Device TC27x
Marking/Step ES-DC, DC
Package see Data Sheet

10318AERRA

This Errata Sheet describes the deviations from the current user documentation.

Figure 4 Example sequence showing how registers ETRRx may be filled with “Error Free” addresses

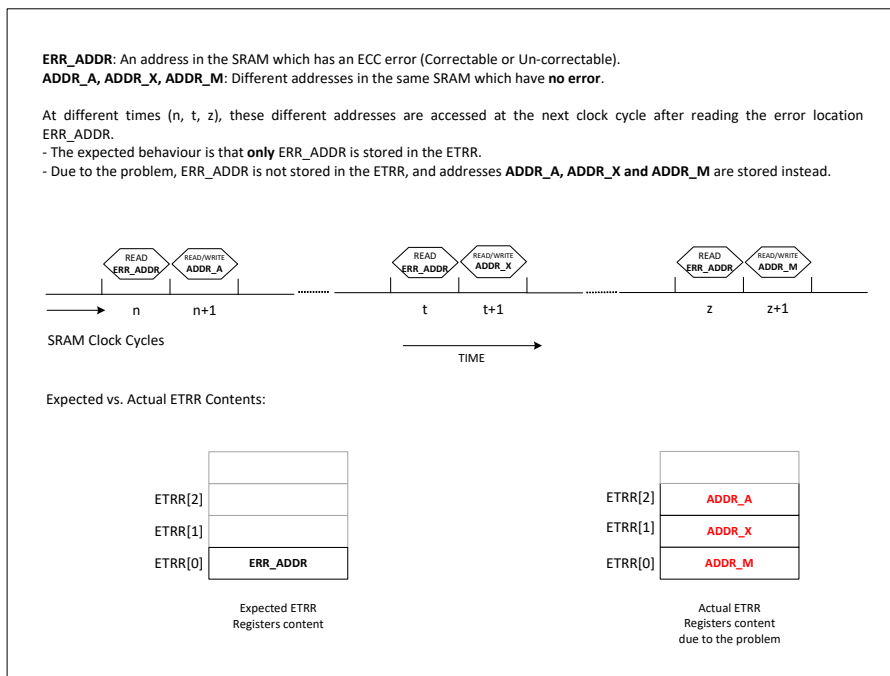
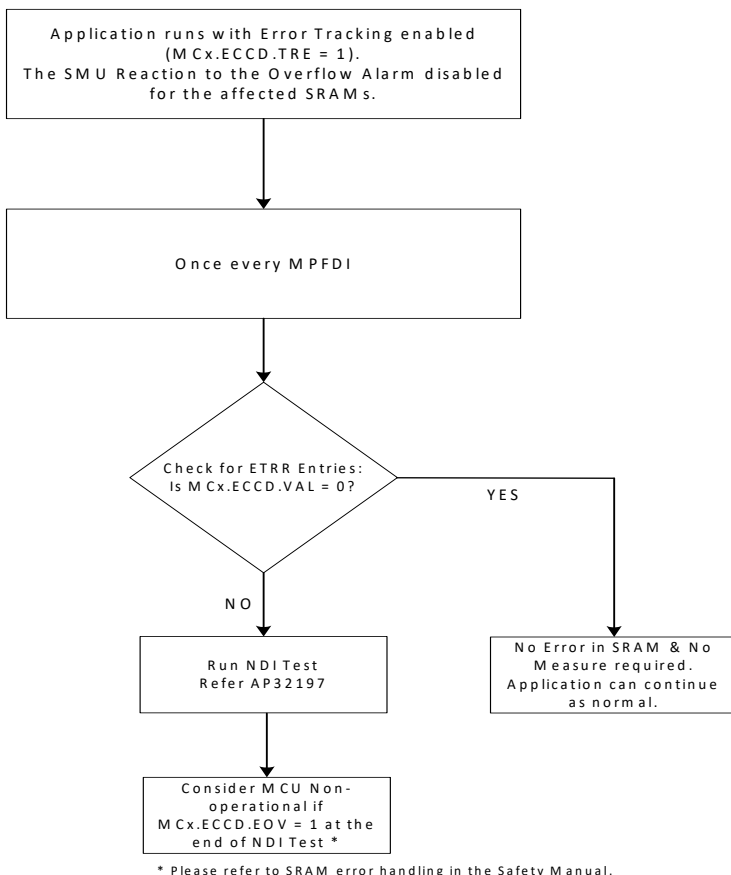
When such a consecutive access sequence (read from ERR_ADDR followed by read/write of different address(es)) happens multiple times, registers ETRRx are filled with addresses that have actually no error – and the SRAM address which actually has an error is not stored indeed. **Figure 4** shows such an example scenario.

The consequence of the scenario explained in **Figure 4** is that a single error in the SRAM – example just one correctable error at a location ERR_ADDR – can result in registers ETRRx getting filled with fault-free address, and thus potentially even triggering an ETRR overflow.

A flowchart of the recommended software handling is shown in [Figure 5](#).

If there is at least one valid ETRR entry (i.e. $MCx.ECCD.VAL \neq 0$) then the software shall run a Non-Destructive-Inversion (NDI) Test on the affected SRAM. Please refer to application note AP32197 (AURIX™ Memory tests using the MTU) for an example regarding running this test.

At the end of this test, if an ETRR overflow is detected ($MCx.ECCD.EOV = 1_B$) then the MCU shall be considered non-operational. Refer to section on Correctable SRAM Error handling in the Safety Manual.

Figure 15 Package Outlines LQFP-176 for TC27x

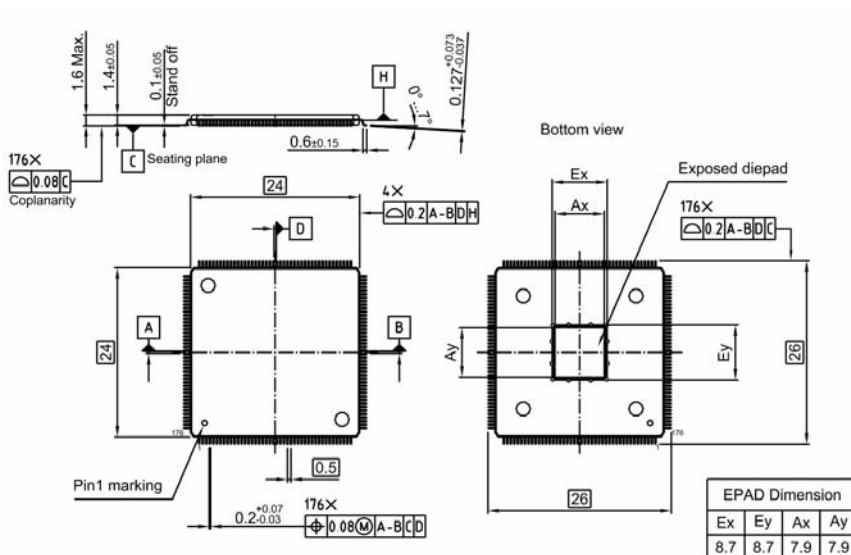
This information shall substitute the corresponding information in the TC27x CA-step Data Sheet V1.1, TC27x DB-step Data Sheet V1.2, and TC27x DC-step Data Sheet V1.2.

Note: For the exposed pad of the LQFP-176 package of the TC27x, structural corner protrusions have to be considered for purposes of system design and integration with a maximum boundary of 9.4 mm.

Figure 18 SENT Tolerance of this Design Step

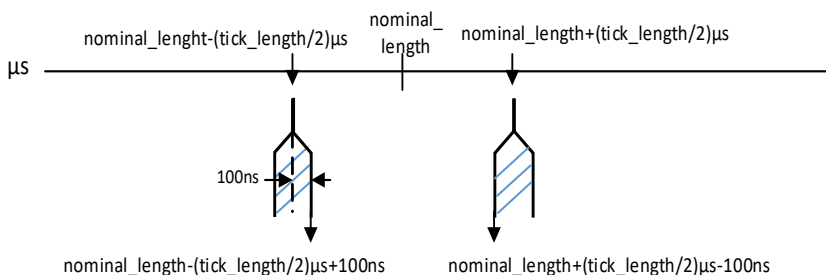
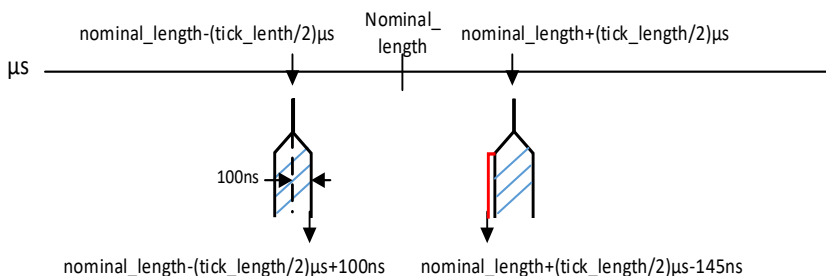
In this design step the range is delimited as follows:

- The lower border is $\text{nominal_value} - (\text{tick_length}/2) \mu\text{s} + 100 \text{ ns}$
- The upper border is $\text{nominal_value} + (\text{tick_length}/2) \mu\text{s} - 145 \text{ ns}$.

Figure 19 Short Serial Message, Serial Data Encoding over 16 messages

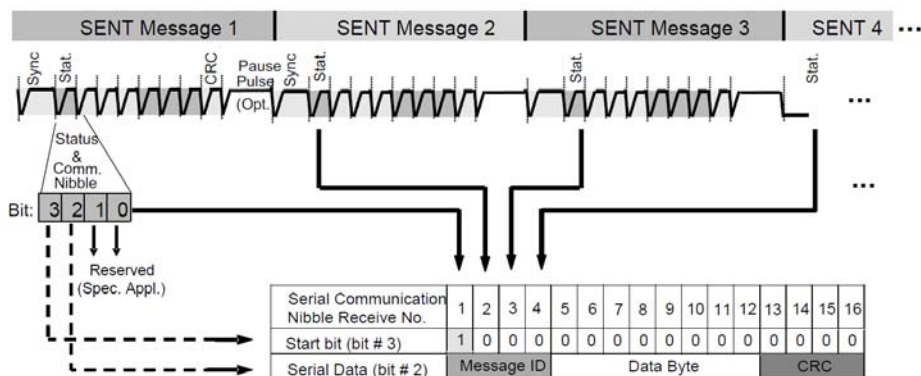
In Figure “Short Serial Message, Serial Data Encoding over 16 messages” of the SENT chapter, the arrows originating from bits 2 and 3 of the Status & Comm Nibble are routed incorrectly and must be swapped.

Figure 19 shows a corrected version of this figure.
